From:	stuart spencer
Sent:	08 August 2024 11:38
То:	Gatwick Airport
Subject:	Wrong positioning of BOGNA swath in GALs noise modelling

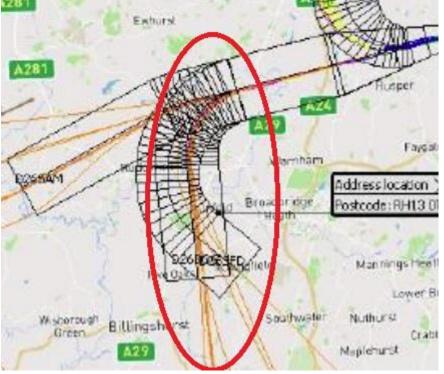
Can I ask if this issue is being looked into by yourselves? To assist you I have now obtained a NATS produced heat map from 2016/17 which was used by GAL in an earlier consultation to representatively show traffic patterns and overlaid that with the BOGNA assumed position from the documents in the NRP that you sent me. The result clearly shows GAL are not using representative or worst case routings in their noise model as below: red arrow shows actual heatmap, light blue arrow shows GALs miss-placed traffic.

I believe I have now supplied sufficient evidence to justify an investigation by yourselves - the discrepancy WILL lead to lower noise impacts - so is an advantage to the applicant. The other question to be

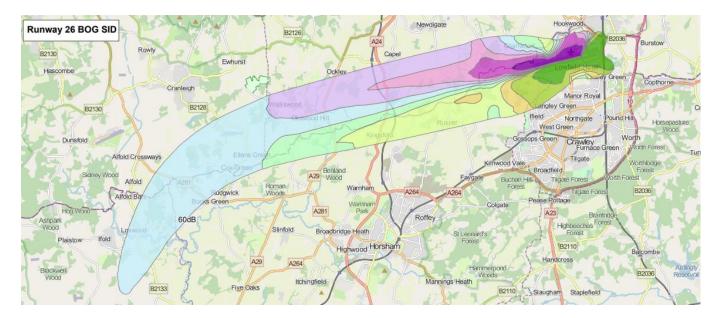
Thanks for sending the information, but it looks like the BOGNA SID noise impact has been assessed by GAL using an average position of plane intensity (the method to reach this is unexplained) and not using either the published PRNAV/SID position nor the line that currently causes most disturbance. GALs approach will significantly and materially underestimate the worst case noise scenario. Below is the worst case position which shows the vast majority of planes flying over or within a 1 mile radius of Slinfold. The published BOGNA SID area is shown in black heading south.

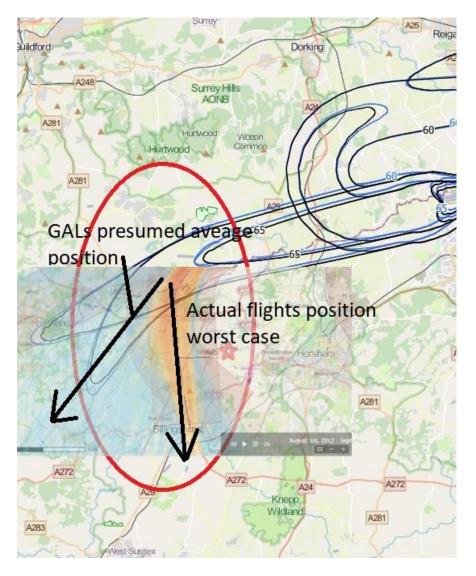
and this does not match what you have sent me in the screen grab as below. This will mean the impacts in the BOGNA swath will be completely wrong. Has this been raised with the applicant?

To see the magnitude of the difference we can lay the two positions on top of each other as below.

The two positions are very, very different. The orange heat distribution shows GAL'S used position is clearly unrepresentative and the consequence is this will not portray either a realistic or worst case noise impact from the proposed development. Has this been raised with the applicant?
